**BMAA Defect Alert #0069: Rotax 912 Series - Inspection and/or replacement of the valve push-rod assembly**

**Applicability:** Rotax 912UL, 912ULS, 914UL & 912 iS Sport

# Inspection and/or replacement of the valve push-rod assy., rocker arm left and rocker arm right for ROTAX® Engine Type 912 i, 912 and 914 (Series)

ATA System: 72-30-00 Cylinder head

Fig. 1  
Visual inspection

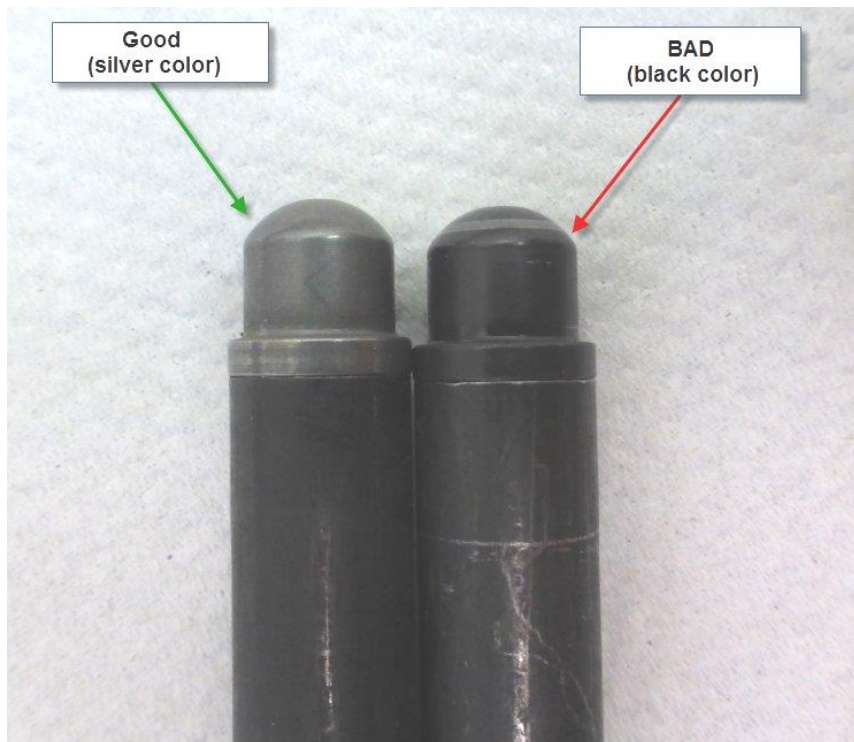
Essentially there are two different types of push-rod, a diagram of the push-rods can be found in Appendix 4 of the bulletin:

*Fig. 1*  
*Visual inspection*

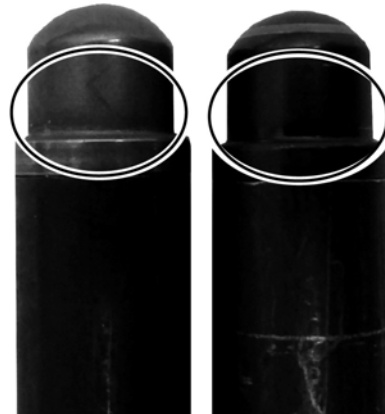
Perform visual inspection of all push-rod ball sockets on all cylinder.

Check for color. See Fig. 1.

**GOOD**  
(silver color)

**BAD**  
(black color)

Color	Evaluation
Silver surface	Valve push-rod is OK. No further action required for this valve push-rod.
Black surface	Valve push-rod is NOT OK. See section. <a href="#">3.1.3) Replacement of affected parts.</a>

Fig. 2

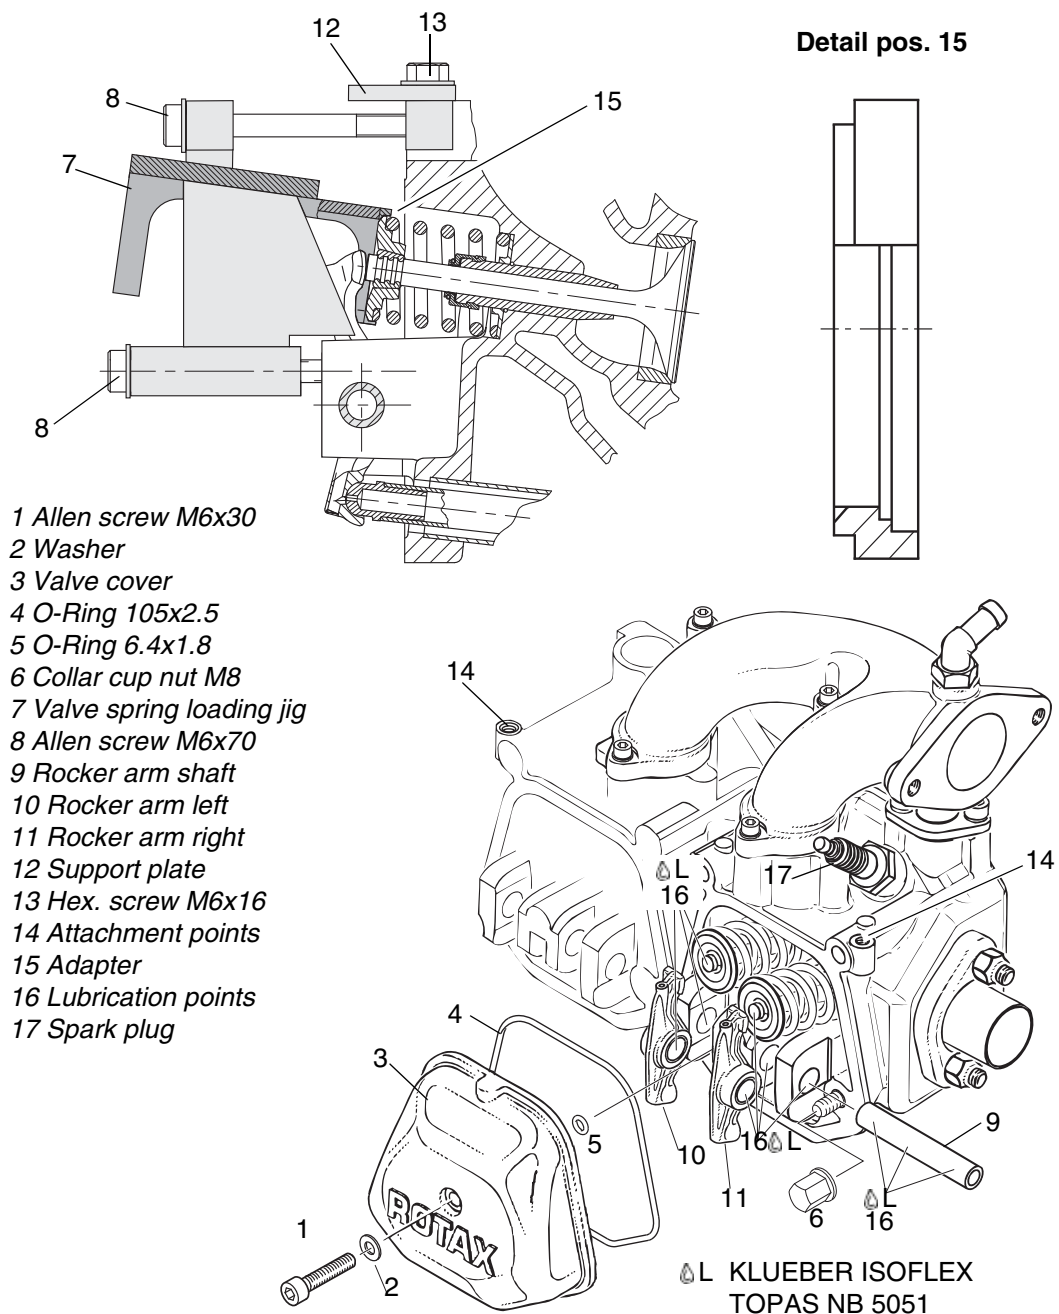
See Fig. 2.

Step	Procedure
1	Loosen Allen screw (1) M6x30 with washer (2) from valve cover (3), and remove it together with large and small O-rings (4) and (5).

See [Fig. 2](#).

Step	Procedure
1	Clean the sealing surface of cylinder head and valve cover with a suitable lint-free cloth or equivalent.
2	Insert new O-ring (4) 105x2.5 and O-ring (5) 6.4x1.8 into the valve cover (3).
3	Fit valve cover.

Between the valve covers a gap of min. 0,1 mm (.004 in.) must remain. The covers must not touch each other.

Step	Procedure
4	Tighten the new Allen screw (1) M6x30 with washer (2) to 10 Nm (89 in.lb).

Fig. 3

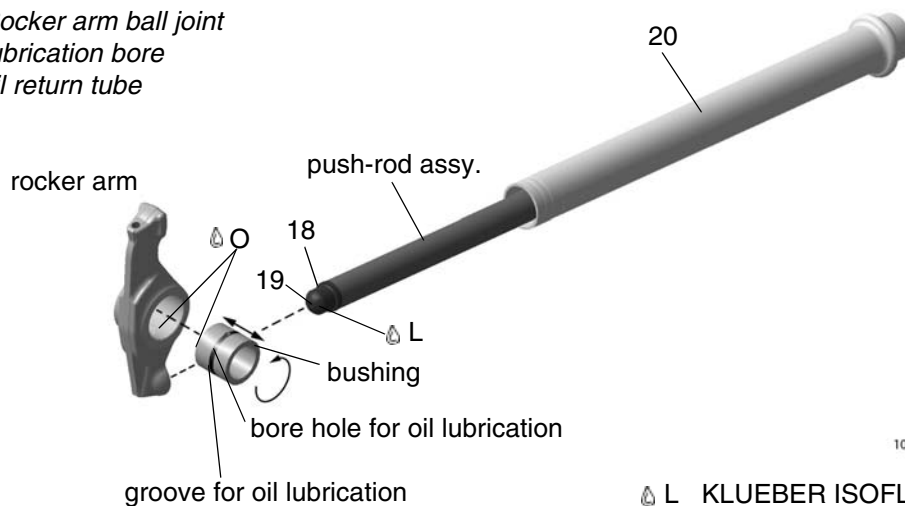
See [Fig. 2](#) and [Fig. 3](#).

Step	Procedure
6	This will relieve the pressure from both hydraulic tappets. Now the rocker arm shaft (9) may be easily pulled out. Lift out both rocker arms (10) and (11).
7	Replace only affected parts as per <a href="#">section 2.3</a> . See also <a href="#">Fig. 3</a> .
8	Apply KLÜBER ISOFLEX TOPAS NB 5051 (16) on both push-rod ball sockets and contact areas of rocker arm and slide push-rod into the oil return tube (20).
9	Check bushing and rocker arm shaft according to latest Maintenance Manual Heavy.
10	Put oil on the rocker arm bushing.
11	Place rocker arm left (10) and rocker arm right (11) in cylinder head, apply KLÜBER ISOFLEX TOPAS NB 5051 (16) on rocker arm shaft (9) and insert it into its bearing support.
12	Loosen valve spring loading jig and support plate.
13	When removing the valve spring loading jig, make sure the adapter rings (15) do not jam on the valve spring retainer.
14	NOTE: Only when you have an Criterion B) Spare parts affected engine and only if engine is equipped with collar cap nuts M8 wrench size 13: Mount collar cap nut (6) according to latest Maintenance Manual Heavy or SI-912-025/SI-914-026/SI-912 i-010.
